Disposal No. P. 195/25.

Subject 21, S. R-3 Serai Dec.

NOTICE UNDER SCHEDULE VI CHAPTER XI, RULE 2 (I) OF
THE CITY OF KARACHI MUNICIPAL ACT 1933.Karachi 14th March 1935

Pursuant to the provision of Schedule VI, Chapter XI, Rule (1) of the City of Karachi Municipal Act 1933, I hereby give you notice that I intend within the meaning of that rule to erect a building on plot No. 21 Survey Sheet S.R. 3 Situated in Serai Road street Serai Quarter

SITE PLAN

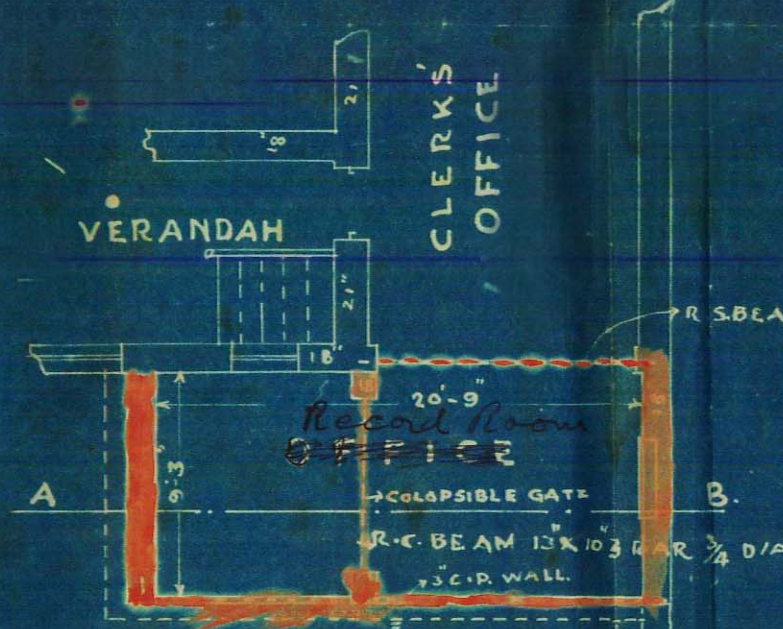
- (1) Does the plot come under Alignment? No -
- (2) If so, is the street line correctly shown. _____
- (3) Does the plot come under the T. P. Scheme? _____
- (4) If so, is the plot shown as finally re-constituted. _____
- (5) Is there any encroachment? no
- (6) If so, state the nature and No. of sq. yds. _____
- (7) Is the plot subject to any conditions of previous sub-division and Amalgamation? _____
- (8) If so, state the conditions. _____
- (9) Is the street width correctly shown? not shown -

(1) *Side measurements require to be shown*

(2) *Street width must be correctly shown*

Submitted
 measurements & width of the road
 are still wrong.

Objection Nos:2 & 3 complied with.

FIRST FLOOR PLAN

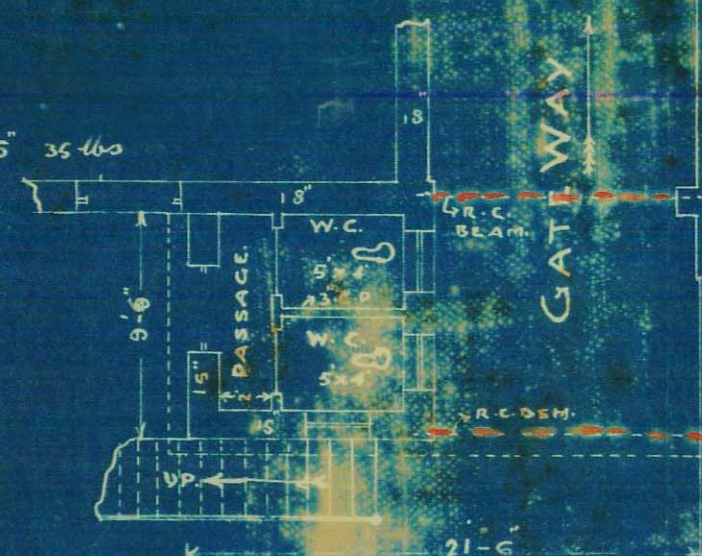
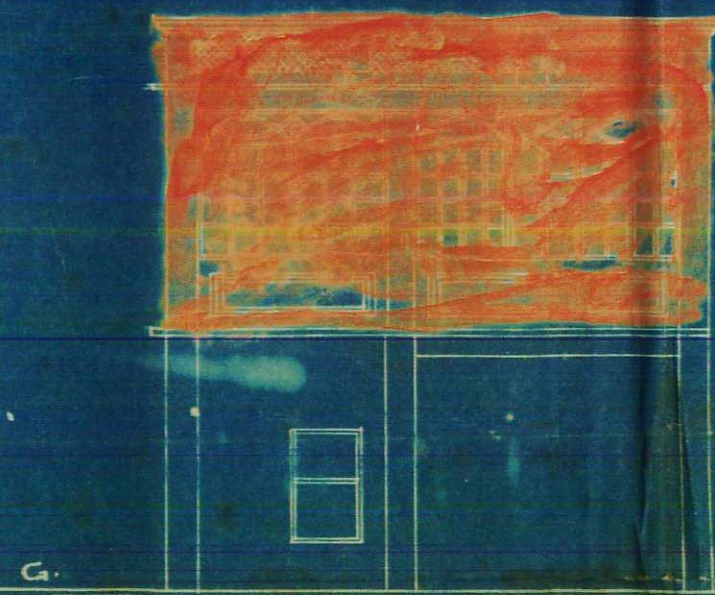
Office cannot be allowed
along w.c's

- (1) Office over the W.C. can not be allowed.
(2) The existing wall is not 15" thick
even with plaster. Upper story on that is
not permissible.

1. Office cannot be allowed over w.c.s
- ✓ 2. Site measurements require to be shown.
- ✓ 3. Street width must be correctly shown.
4. The existing wall is not 15 thick even with plaster.
Upper storey on that is not permissible.

The objection of L.S
 are not complied with, nor
 is the wall 15" in thickness
 as already intimated.

1. The matter was reported to the Chief Officer who decided that a record room over w.c. cannot be allowed under Schedule VI, Chapter I Rule 17 of the City Municipal Act.

Objection No:1 It is a record room and not
office and will not be used
for clerks at all.

Objection No: 4 The existing wall is 15"
thick excluding plaster.

L. M. & A.
On reconsideration, I am of opinion that the plan be allowed for record room over w.c.
13/6/35
